Value Engineering Study Report

Georgia Department of Transportation
CSSTP-0007-00(414) - P.I. No. 0007414

**CR90/ Colerain Road from I-95 to Kings Bay Road
Camden County**

RE: Submittal of the final Value Engineering Report
Colerain Road from I-95 to Kings Bay Road
Project Nos.: CSSTP-0007-00(414) – P.I. No. 0007414

ALTERNATIVE NO.:
RD-20

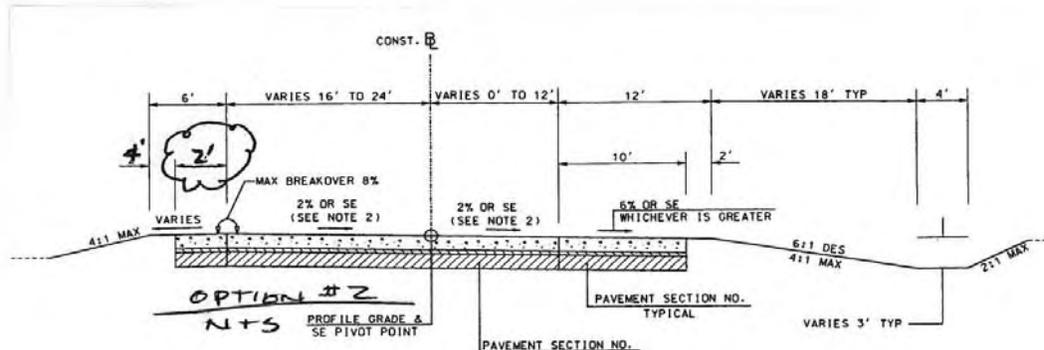
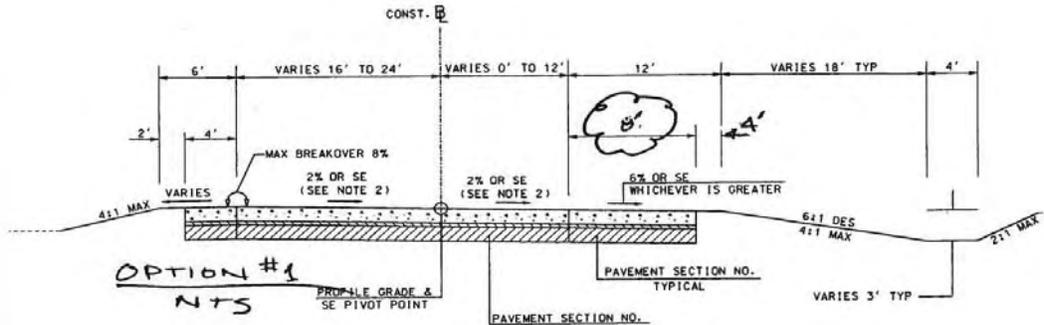
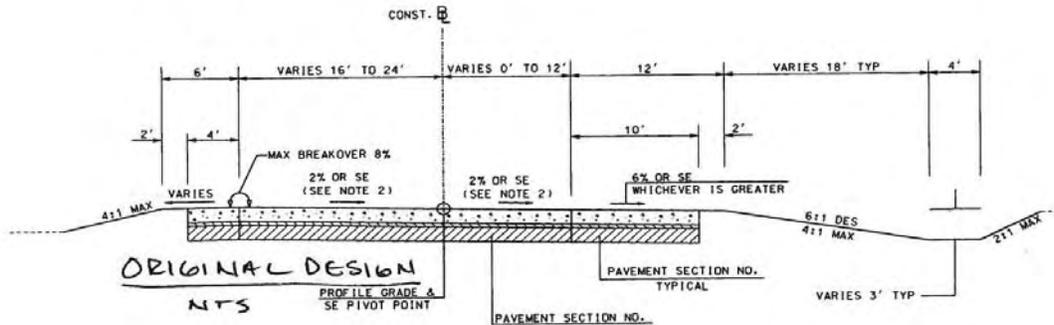
PROJECT:	Georgia Department of Transportation CSSTP-0007-00(414) - P.I. No. 0007414 CR90/Colerain Road from I-95 to Kings Bay Road Camden County	ALTERNATIVE NO.:	RD-20
DESCRIPTION:	Reduce the sum of the ramp shoulders from 14' to 12'	SHEET NO.:	4 of 4
